SERVICE BULLETIN

Product: CRT MONITOR _____ **Bulletin No.:** MON02-010 (02-C/M-E0081) _____
Model: AQ19LS, AQ19JS _____ **Bulletin Date:** August 28, 2002 _____
ECN Date: August 28, 2002 _____

SUBJECT: Main PCB and Chassis Frame _____

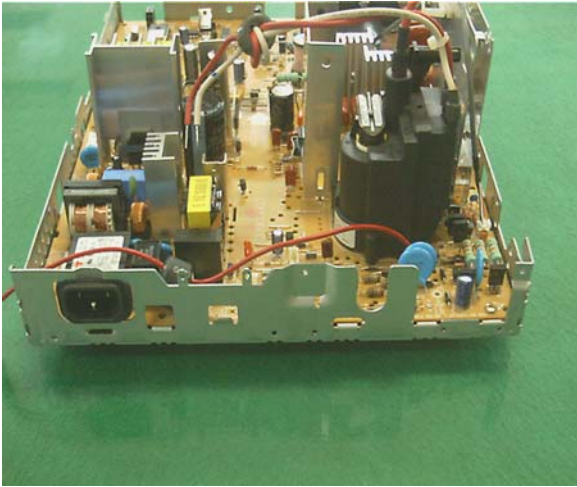
Background: The main PCB touches the metal chassis frame guides. Although the PCB is covered with protective paint, it may cause failures to R513 and R570.

Cause: The protective paint wears out with PCB version range MP 1.2 ~ MP 1.4 with a production date of October 2001 ~ August 2002. Permanent solution : Change PCB pattern from ver 1.4 to ver 1.5 (Sep.2002~)

Solution: Changing the PCB pattern from version 1.4 to version 1.5.
 For all MP 1.2 – MP 1.4 in the field, bend the guide to prevent the PCB from touching the metal frame.
 See page 2 for additional information.

PCB guide part of metal

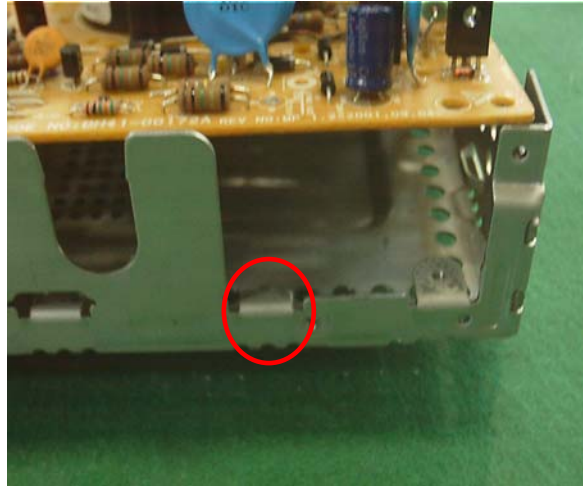
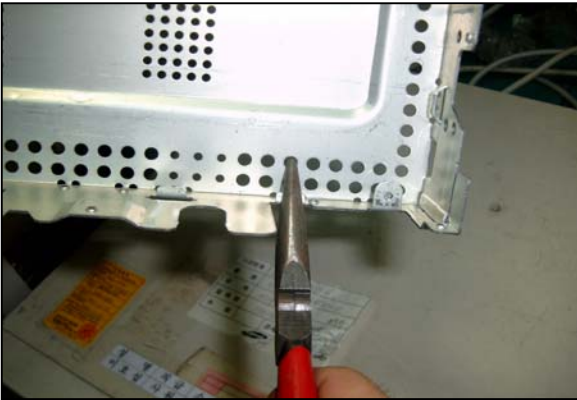
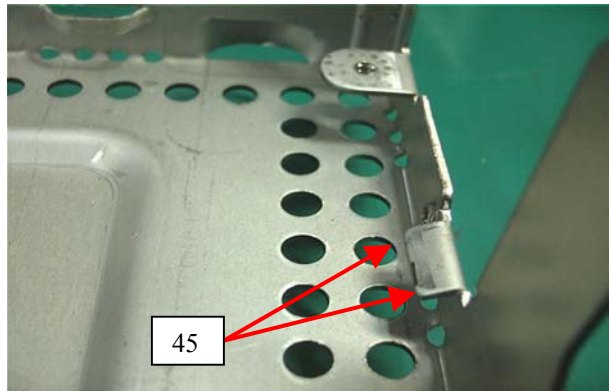
Bend the guide down very carefully.

Bending angle: 45 degree
